Appl. No. 09/844,840  
Amdt. Dated July 30, 2004  
Reply to Office action of April 30, 2004  
Replacement Sheet  
**APPENDIX**

Replacement Sheet for Figures 1 and 4

**FIG. 1**

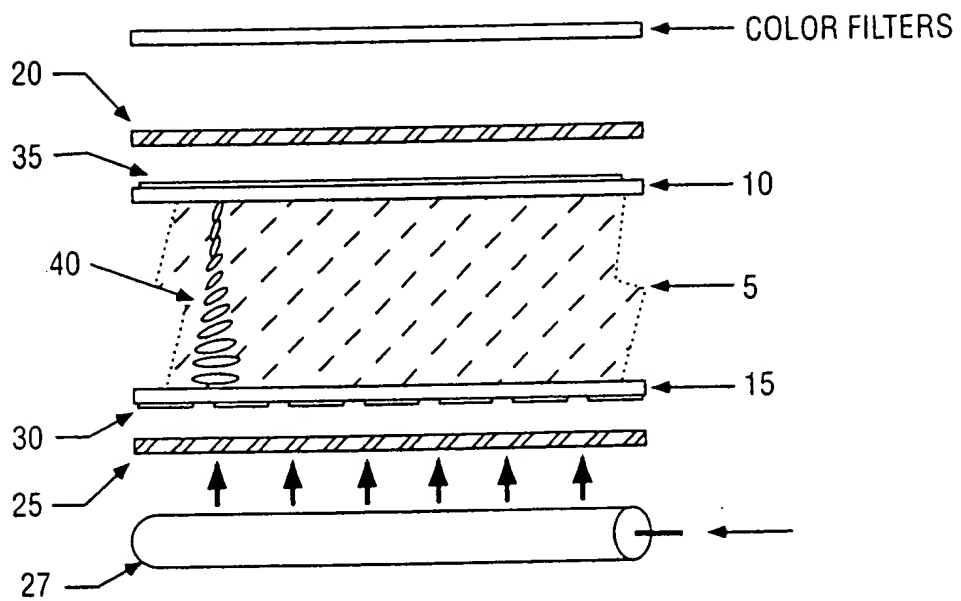
The attached sheets of drawings includes changes to Figs. 1 and 4. These sheets, which include Figs. 1 and 4, replace their corresponding original sheets. In Figure 1, previously omitted "Prior Art" legend has been added. For Figure 4, the synchronizer is shown with a "digital timer connected to the voltage controller" as requested by the Examiner. No new matter has been added.
